APPENDIX 4 – DEVELOPMENT SITES AND STRATEGY EVALUATION (DSSOE) – BRIEF ADDITIONAL CLARIFICATION

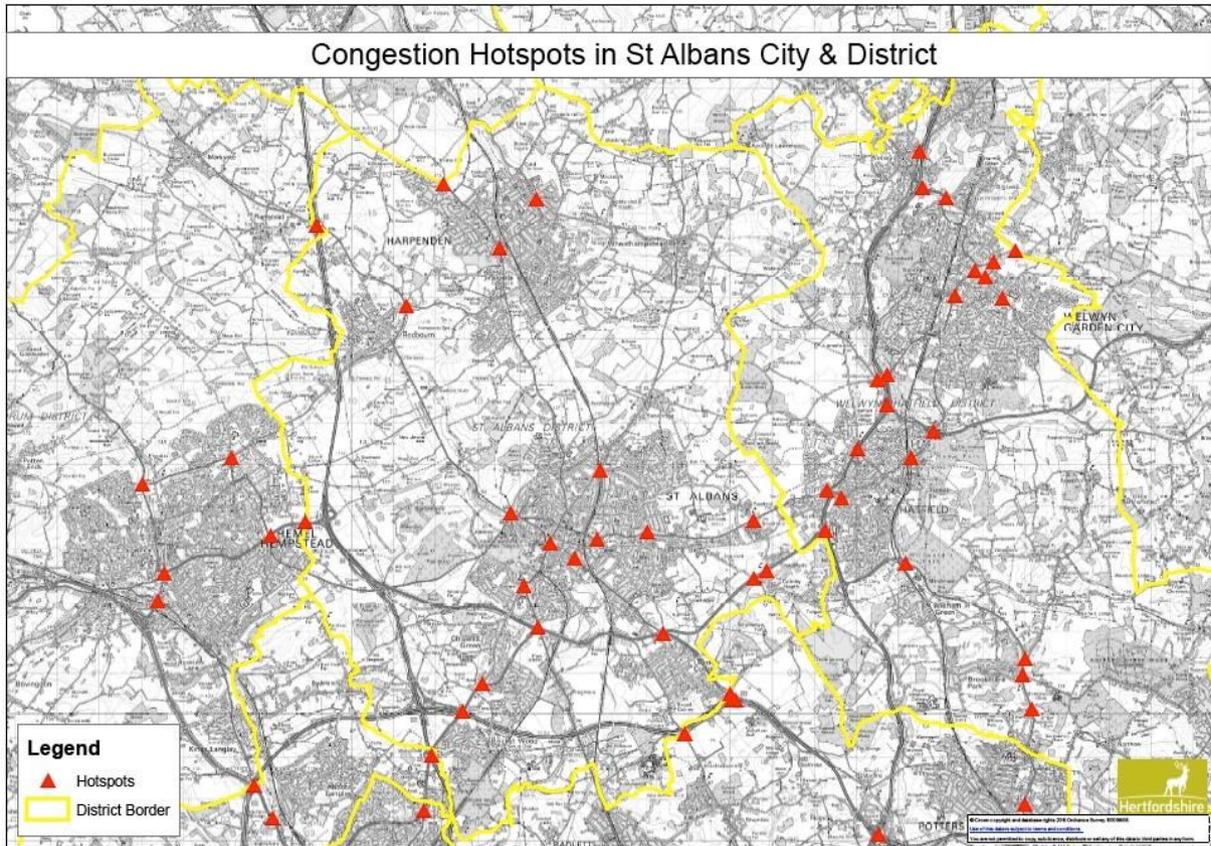
29. What officers have omitted to inform PPC members when rescoring the sites is that as of 2016, HCC considers the stretch of the A1081 adjacent to NW Harpenden to be a “congestion hotspot” but no longer regards the A1081 next to North of St Albans to be one, as this graphic shows:

How did this information come to be omitted, when officers were undertaking the rescoring of these sites specifically in relation to traffic congestion, and in the light of sustained public criticism of the previous scores? Did officers fail to ask HCC because they were not interested in having HCC's views but only in maintaining the existing ranking of sites?
